CITY OF MERCER ISLAND

October 26, 2017

RE: CAO17-007 (Critical Area Determination for 4634 E Mercer Way)

**Re: Geotechnical Review
Proposed Single-Family Residence Development
4634 East Mercer Way, Mercer Island, Washington
City of Mercer Island Permit No. 1507-166**

10. Depression and cracking of access road pavement along top of slope.

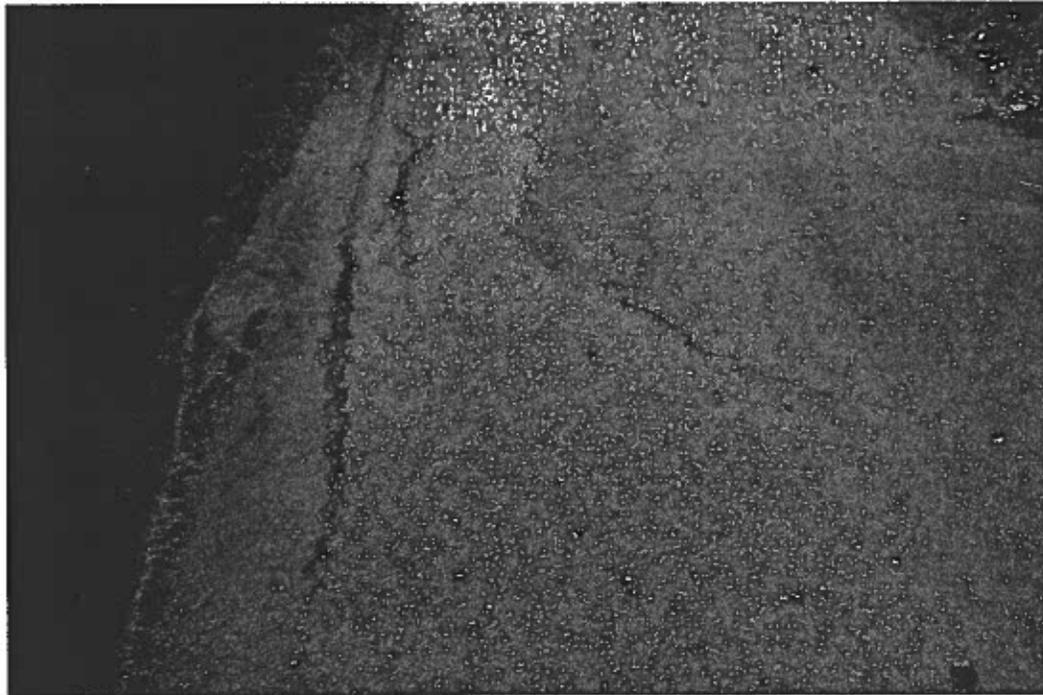
9. Depression and cracking of access road pavement along top of slope.
